DEVELOPMENT APPLICATION ASSESSMENT REPORT

Application Number:	DA2023/0299
---------------------	-------------

Responsible Officer:	Claire Ryan
Land to be developed (Address):	Lot 82 DP 8076, 35 Reddall Street MANLY NSW 2095 Lot 83 DP 8076, 31 Reddall Street MANLY NSW 2095 Lot 84 DP 8076, 29 Reddall Street MANLY NSW 2095
Proposed Development:	Demolition works, subdivision of three lots into five and construction of five new dwelling houses with swimming pools, associated landscaping and parking.
Zoning:	Manly LEP2013 - Land zoned R1 General Residential
Development Permissible:	Yes
Existing Use Rights:	No
Consent Authority:	Northern Beaches Council
Delegation Level:	NBLPP
Land and Environment Court Action:	Yes
Owner:	The Trustees Of The Roman Catholic Church For The Archdiocese Of Sydney Reddall Street Pty Ltd
Applicant:	The Trustee For Reddall Street Trust

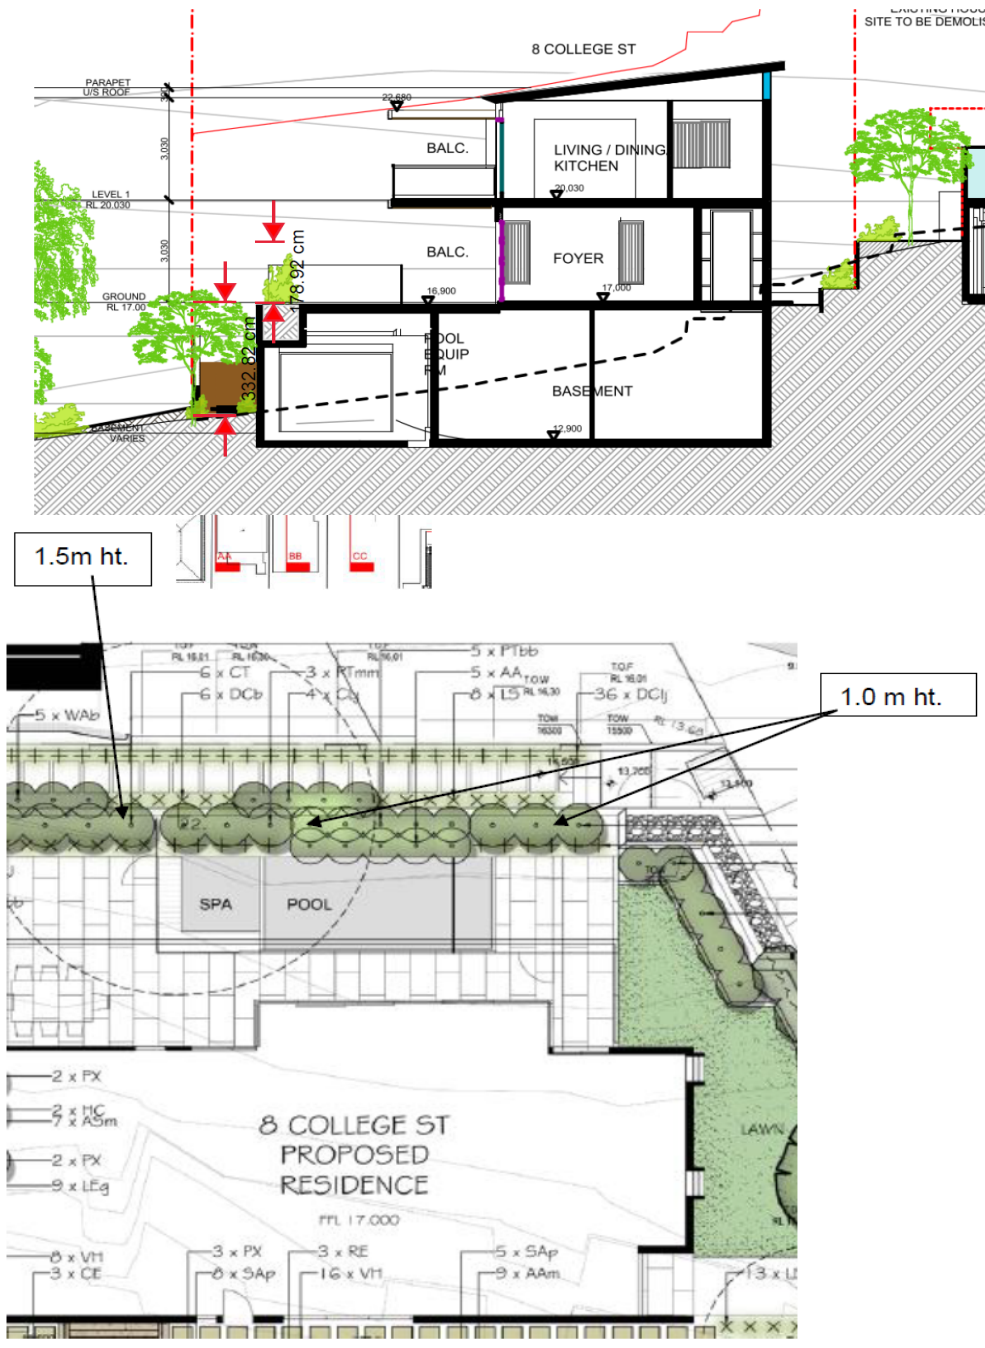
Internal Referral Body	Comments
	(Port Jackson Fig) is rated Medium retention value. All other trees have been rated Low retention value. T19 is described a being in Fair condition and <i>Locally indigenous species</i>. <i>Codominant stem to S removed, with resulting epicormic growth low on remaining stem and pruned stub. Falls well within the proposed development footprint and would be removed.</i> The two trees on Council's reserve are immediately adjacent to the property boundary. The trees are T10 <i>Ficus benjamina</i> (Weeping Fig) and T11 <i>Nerium oleander</i> (Oleander). T10 is described as being in Fair condition and <i>Introduced exotic species</i>. <i>On Council reserve. Has been topped and lopped. Salt burn to leaves. F. benjamina</i> is an exempt species under Manly DCP. T11 is described as being in Fair condition and <i>Introduced exotic species</i>. <i>On Council land. N. oleander</i> is an exempt species under Manly DCP. No objections are raised to the proposed tree removals, subject to replanting. The documentation and SEE indicate that the required landscaped open space and soft landscape areas are compliant with the planning controls. Assessment of such is left to planning assessment, however, some aspects of the proposed landscape works may be in conflict with other planning requirements, as discussed below: 1. Landscape plans indicate planting to achieve a height of 1.0 - 1.5 metres height along the rear of No 8 College St. at terrace height Based on the Sections provided, overlooking into the yard and internal space of No. 95 Bower St may be an issue requiring further planning assessment. (Extract from Landscape Plans and Sections 8 College Street below)

Internal Referral Body	Comments
	 2. Similar applies to No 9 College St. (Extract from Landscape Plans and Sections 9 College Street below)

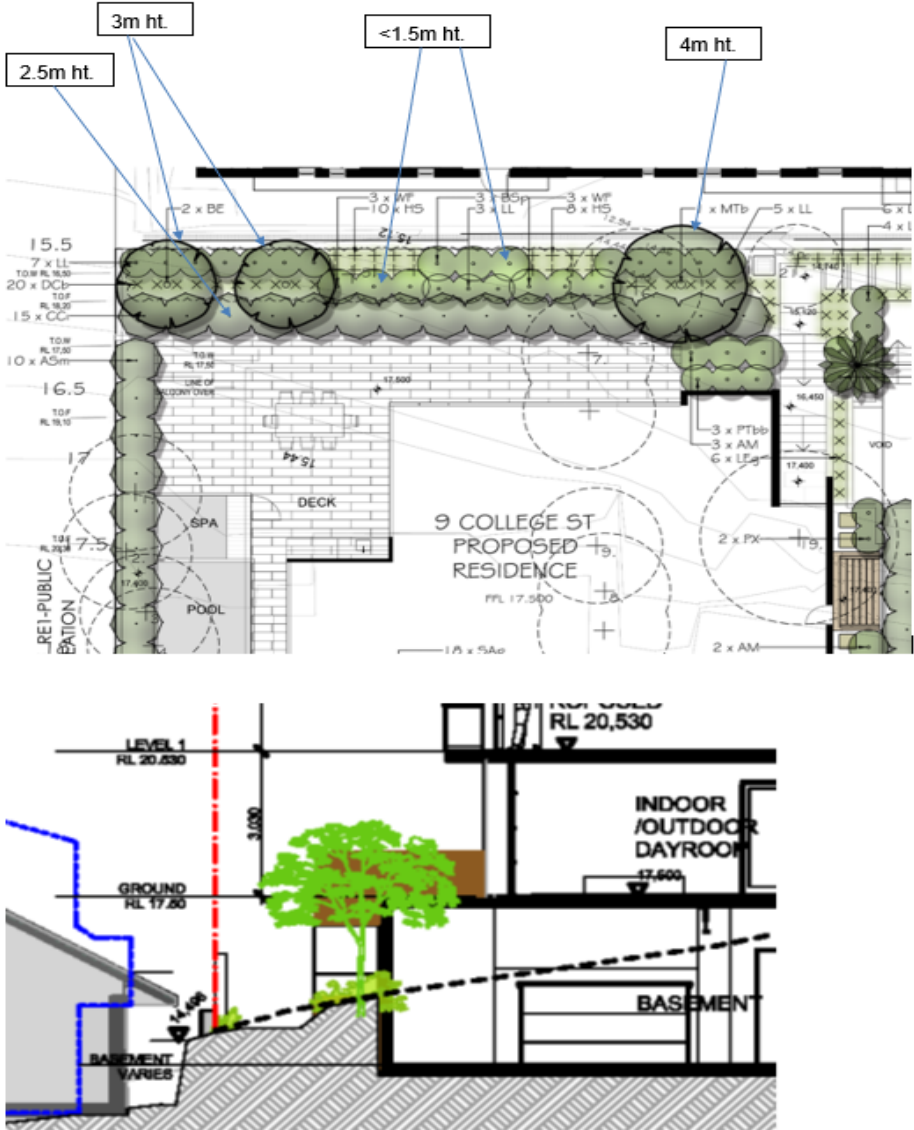
Internal Referral Body	Comments
	 The image contains two architectural drawings. The top drawing is a landscape plan for the '9 COLLEGE ST PROPOSED RESIDENCE'. It shows a rear garden area with a pool, spa, and deck. Various plantings are indicated with codes like '2 x BE', '3 x WP', '10 x HS', '3 x MTb', '5 x LL', '6 x L', '4 x L', '3 x PTbb', '3 x AM', '6 x LE', '2 x PX', and '2 x AM'. Callouts specify tree heights: '2.5m ht.', '3m ht.', '<1.5m ht.', and '4m ht.'. Elevation markers on the left include 15.5, 16.5, and 17. The bottom drawing is a vertical section showing the building's profile. It labels 'LEVEL 1 RL 20,530', 'GROUND RL 17,20', and 'BASEMENT VARIES'. A tree is shown in the garden, and the building interior is labeled 'INDOOR /OUTDOOR DAYROOM' and 'BASEMENT'. A vertical dimension of 3,000 is shown between the ground level and the first floor level. 3. In general terms, the rear retaining walls are quite high (>3 metres height). Built from will be predominant and subsequently cannot rely on soft landscape for amelioration. (Section extract below).

Above: The section through the proposed dwelling houses on proposed Lot 1 (uphill) and proposed Lot 5 (downhill). The extent of the height of buildings breach is highlighted in yellow and is due to the historical excavation for the existing dwelling, shadowed above.

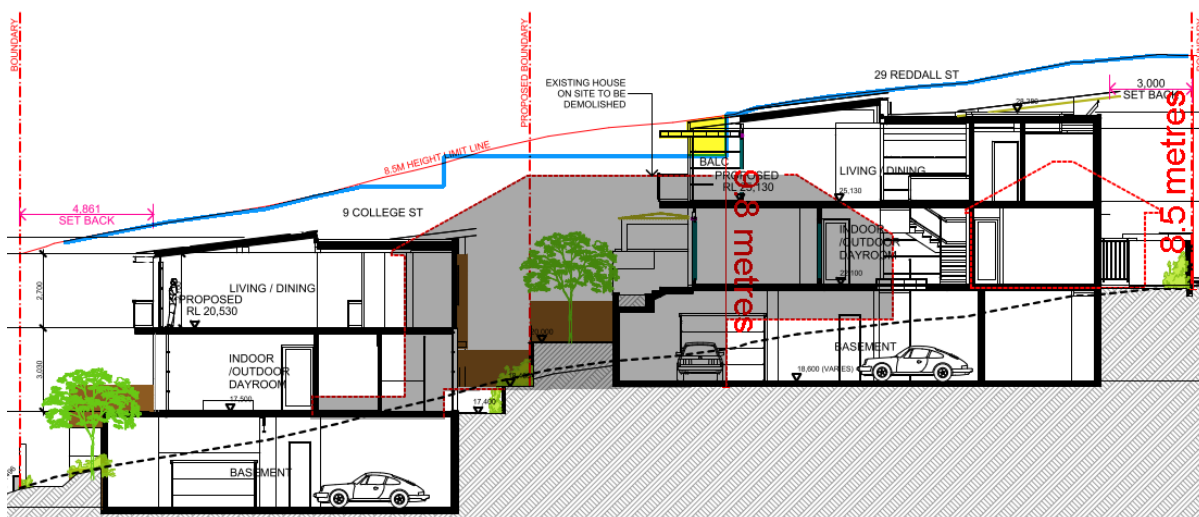
The submitted elevation and section plans do not demonstrate existing ground levels (including where disturbed by development) and extrapolated natural ground levels. Further, the proposed development is not supported by a written request to vary the development standard contained within Clause 4.3 of the MLEP, in accordance with Clause 4.6 Exceptions to Development Standards of the MLEP. It is anticipated that the proposed development will result in view loss attributable to the non-compliant height of buildings, in contravention of objective (c)(ii) of Clause 4.3 of MLEP, which provides:

Building height is calculated from the existing ground level, whether disturbed or undisturbed, as per the judgement in *Merman Investments Pty Ltd v Woollahra Municipal Council* [2021] NSWLEC 1582 by the NSW Land and Environment Court. The proposed development presents variation to the development standard contained within Clause 4.3 of the MLEP, as at least one of the the proposed dwelling houses breaches the maximum height of 8.5 metres above the existing ground levels (i.e. the ground levels of the existing dwelling houses). The dwelling house on proposed Lot 1 includes a height of up to 9.8 metres, where a maximum of 8.5 metres is allowable. It is anticipated that the dwelling houses on proposed Lots 2 and 3 may also breach the maximum building height, though insufficient information has been provided to establish the exact extent of the numerical non-compliance.

Development standard:	Height of Buildings
Requirement:	8.5m
Proposed:	9.8m
Percentage variation to requirement:	15.3%

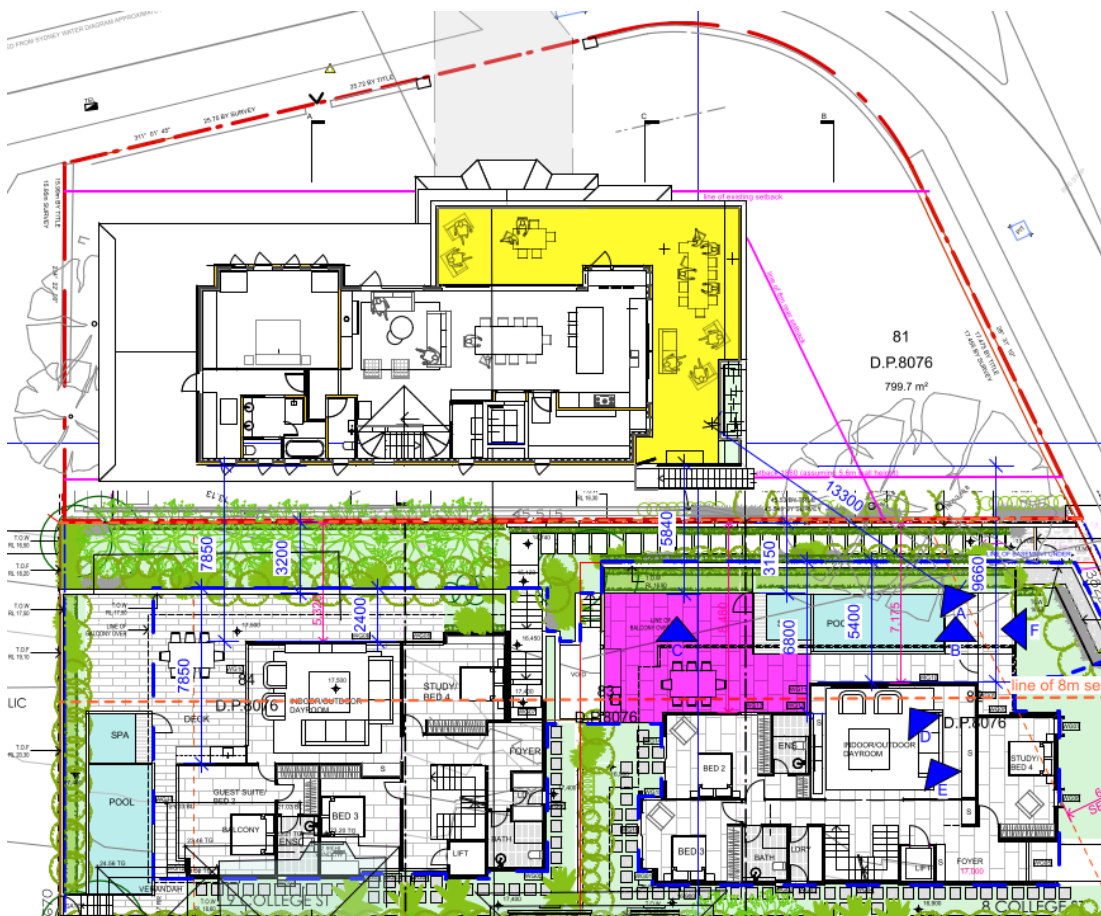
With respect to No. 95 Bower Street to the north-east of the subject site:

The dwelling of concern (on proposed Lot 4) is designed such that it does not result in an unreasonable visual privacy outcome to No. 95 Bower, as follows.

The owners of No. 95 Bower Street raised concern about the new dwelling on proposed Lot 4 overlooking of the private open space areas on their property (which include decks at the ground and first floors, and a landscaped lawn area). The private open space areas of No. 95 Bower Street are located to the south-east of No. 95 Bower Street.

The dwelling on proposed Lot 4 is compliant with the required side setbacks set by Clause 4.1.4.2 of the Manly DCP, with the exception of the basement, which is not a consideration with respect to visual privacy, given that it is not a habitable space. In this way, the proposed dwelling is adequately set away from what will be its north-eastern side boundary, in order to provide suitable separation to No. 95 Bower Street. Additional separation is provided by the battleaxe pedestrian access handle to proposed Lot 5. The owners of No. 95 Bower Street also raised concern about this access handle with respect to privacy. The concern is not agreed with, given this is a point of access only, and not a point

Above: The south-western elevation of the three dwellings facing Reddall Street.

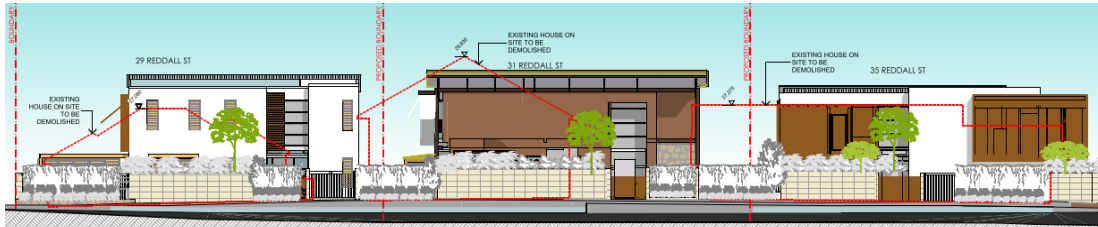
A number of submissions raised concern about the proposed development's impact on views. The Applicant submitted a detailed analysis of the view impact, in accordance with the requirements set by the NSW Land and Environment Court, which assists with assessment of this application.
